DARLING
HARBOUR LIVE
THE SOUTHERN
PRECINCT
SUPPLEMENTARY
DESIGN REPORT
FOR SSDA5

February 2014

This report has been prepared by Denton Corker Marshall in response to the DoPI letter dated 28 November 2013 and addendum. It also addresses the relevant issues raised by the City of Sydney submission to SSDA5. It provides additional clarification and/or response to particular design issues. A full assessment against all of the conditions in Stage 1 DA approval has been prepared as a separate Appendix to the response to submissions.

Podium part section - Hay Street/ Darling Drive

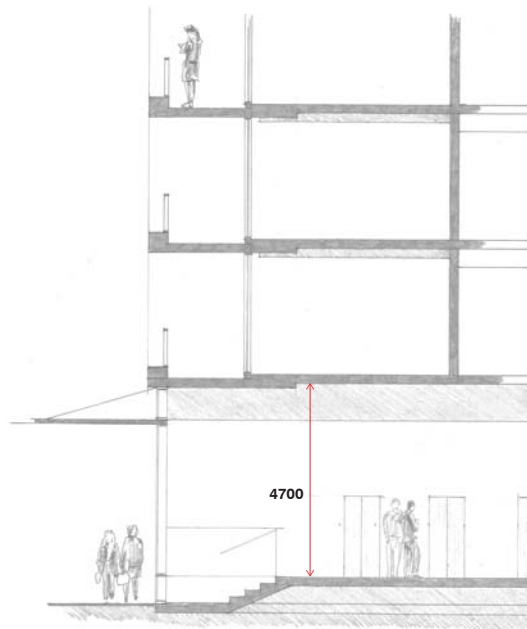
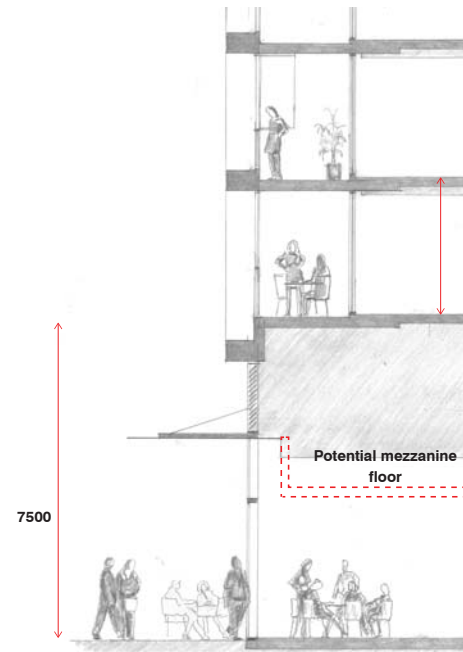
"Include floor-to-floor heights of 3.6m at the first floor level of each tower to provide flexibility of uses."

However by establishing a generous floor to floor height at ground future expansion has been catered for within this development. The floor to floor height at ground level varies from 4.7 metres to nearly 7.5 metres. This tall and varied height has been designed to:

- Maximise the physical separation between residential apartments and street edge retail and entertainment uses as noted in 'Podium apartment screened balconies' overleaf;
- Allow maximum flexibility for retail tenants to provide single, mezzanine or double height fit-out (including future tenants);
- Provide taller floor to floor heights focused along the Boulevard where greater commercial and retail activity is focused and to respond to the civic setting; and
- Consolidate non-residential uses at ground level minimises risk of future acoustic issues between residential and commercial/ retail uses at level one.

Podium part section - screens open

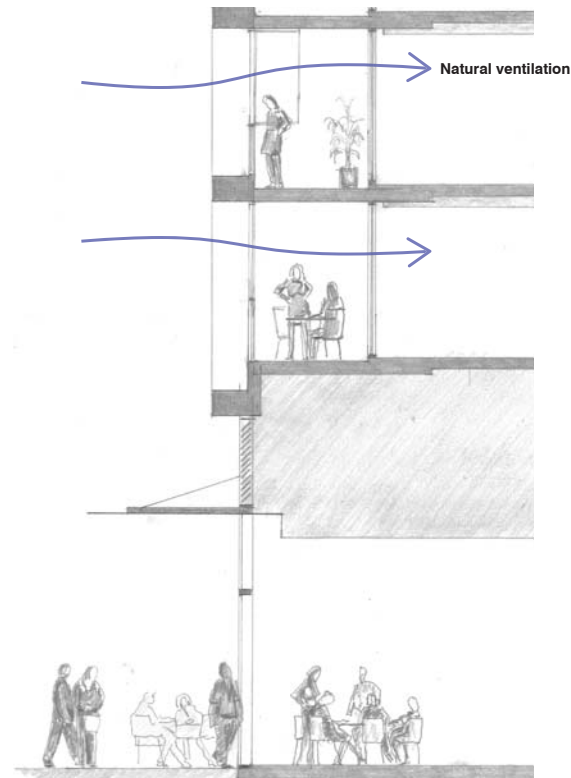
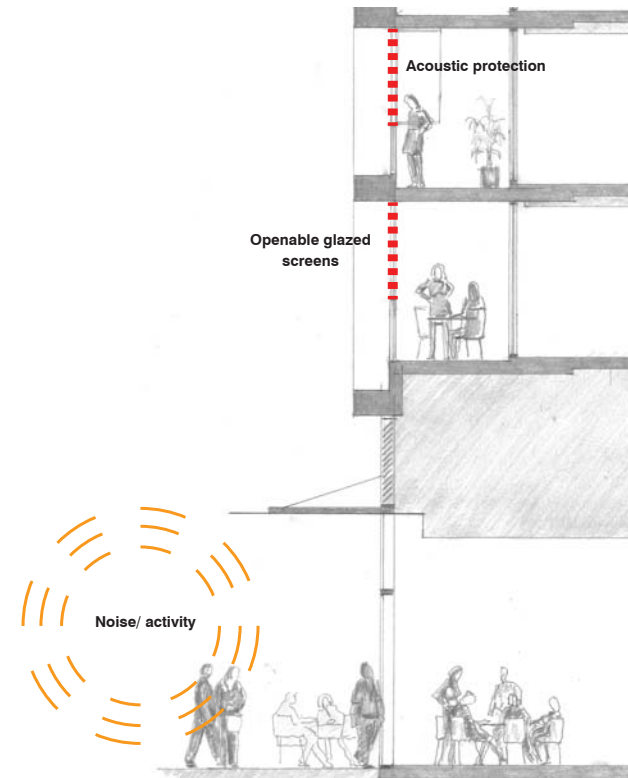
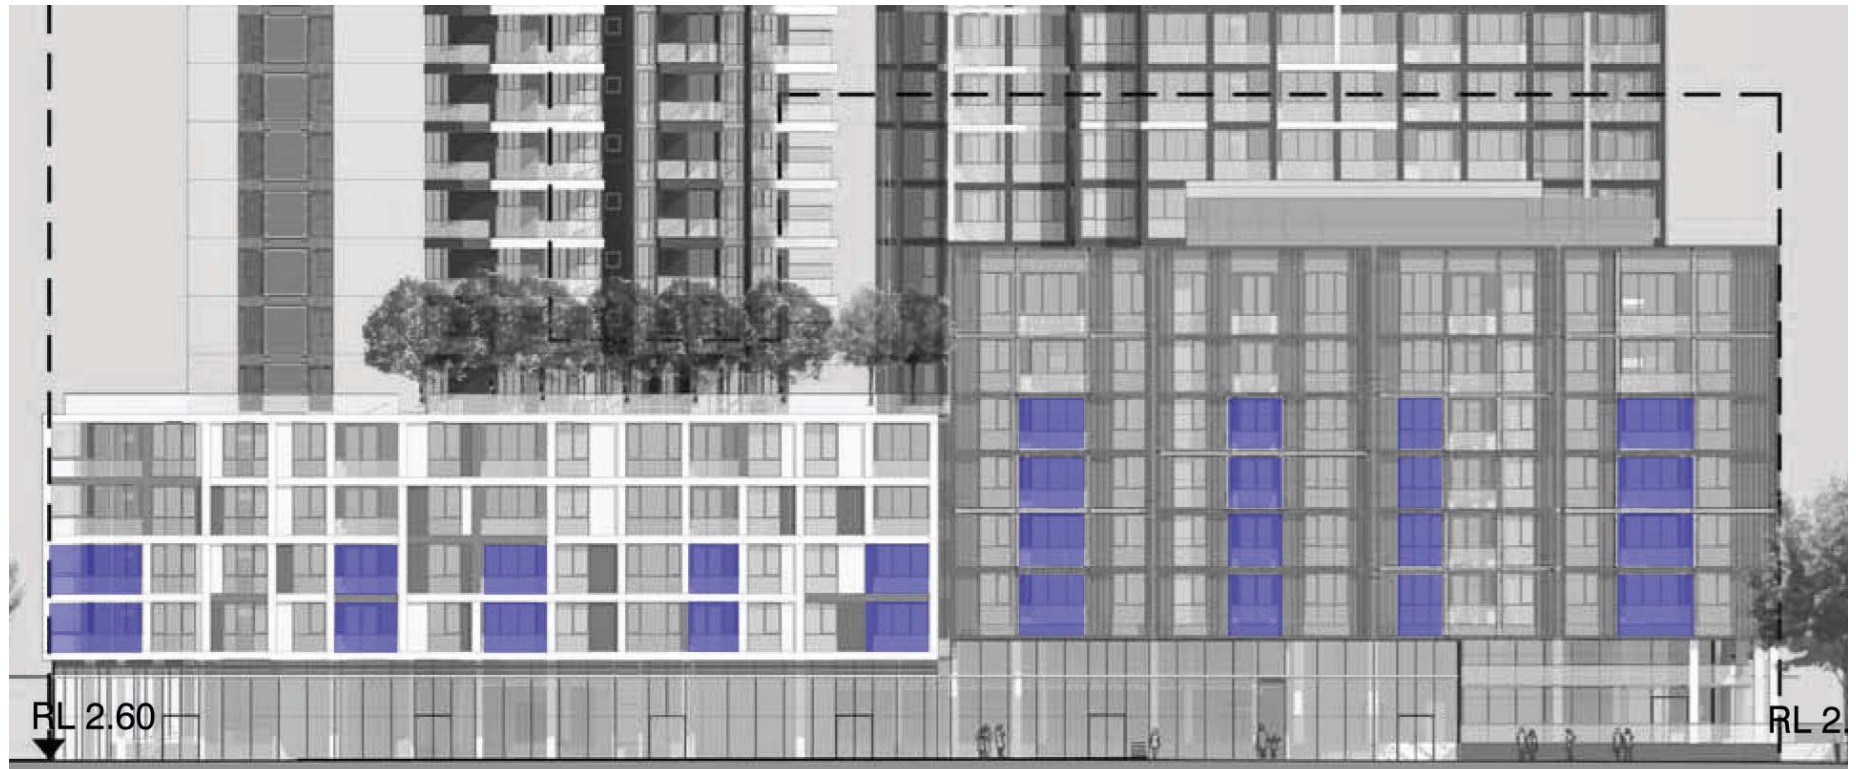
"Consider changing the lower level balconies to sunrooms which can provide some protection from ground plane activities, but allow the room to be opened up as a balcony. This will increase the gross floor area."

The design team note that residential uses were provided around the podium to 'skin' the car park to create a more attractive streetscape in line with the Urban design and Public Realm Guidelines (UDPRG).

- A screened balcony in lieu of a sun-room maintains the functionality of the balcony amenity and the natural ventilation of the apartment;
- Fully openable screens creates visual depth in the reading of the elevations and enriches the architectural experience of the buildings. The potential variation in the balcony screens within apartments and throughout the year will provide visual interest;

- The screened balconies will provide a product differentiation for the future occupiers and allow for more flexible use of spaces addressing changing needs/ use patterns of living.

Resident's community room

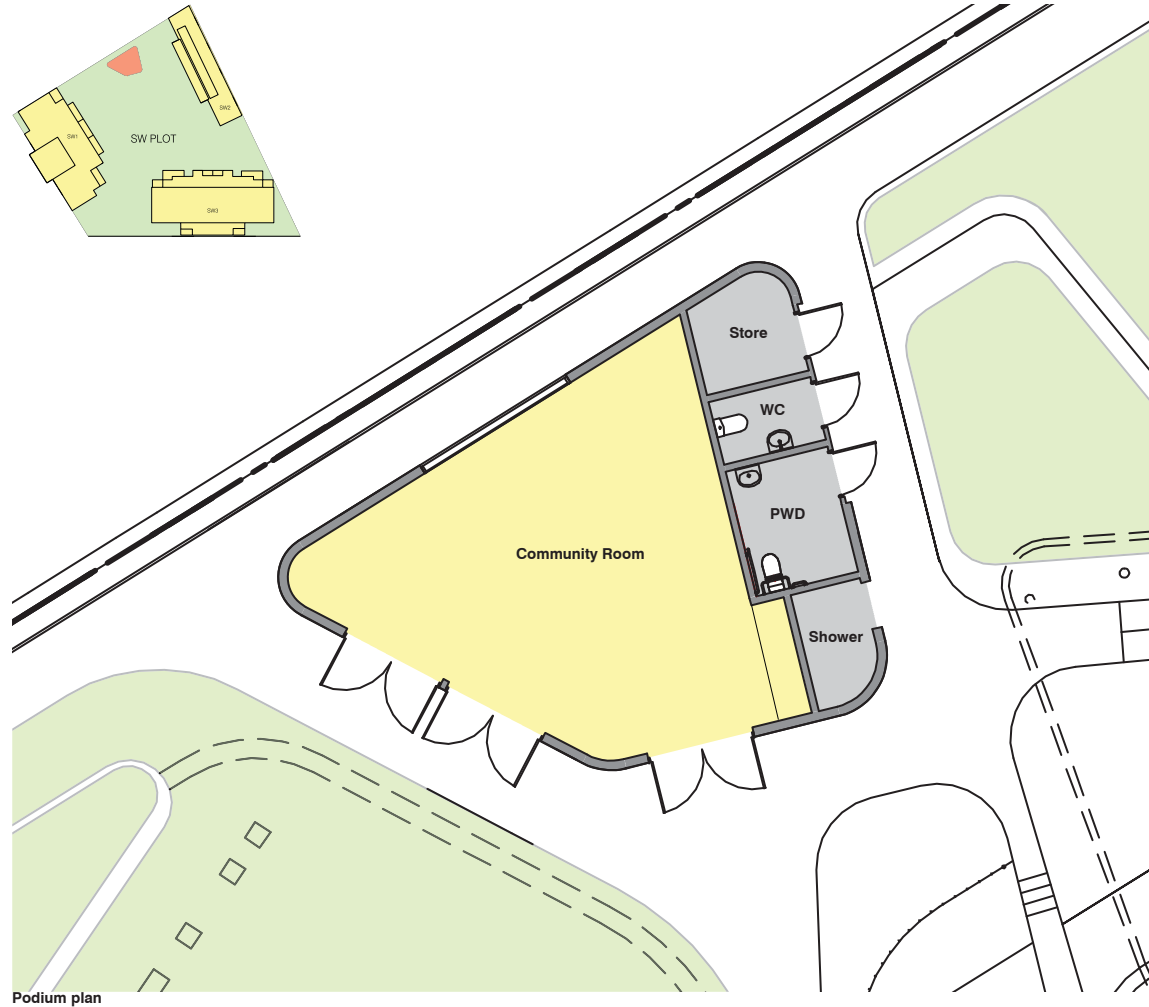
"Consideration should be given to providing a sound-proof community room for residents to have function, meetings or music practice."

- Be a safe and secure facility located in a public place;
- Be accessible to all residents;
- Allow for noisy communal activities – such as band practice – to be located away from residential apartments and minimise neighbour nuisance/ conflict;
- Establish a resident community focal point and encourage interaction and dialogue between residents;
- Provides additional activation of podium landscape with a potentially broad range of programmes and uses;
- Maximise benefit of natural lighting and ventilation to minimise energy use; and
- Provide additional visual screening from the adjacent NW Plot.
